## CITY OF ALBUQUERQUE

Site: Glendesto

Re: Drainage Ordinance (14-5-2-1) Violations for Erosion and Sediment Control and Pollution Prevention

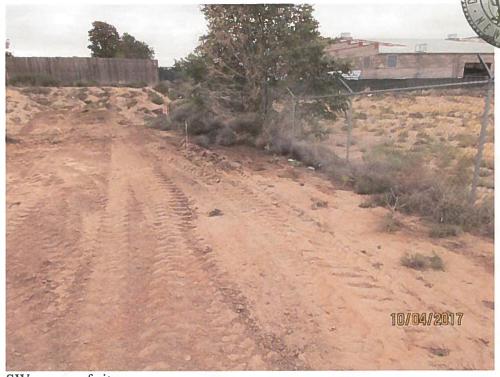
- 1. The site was being graded and there were no BMPs installed.
- 2. There was no chemical toilet.

1. Install BMPS per approved Erosion and Sediment Control Plan with an additional requirement that if grades remain as they exist today a sediment pond or second layer of sediment control is required in the southwest corner as it an outfall.
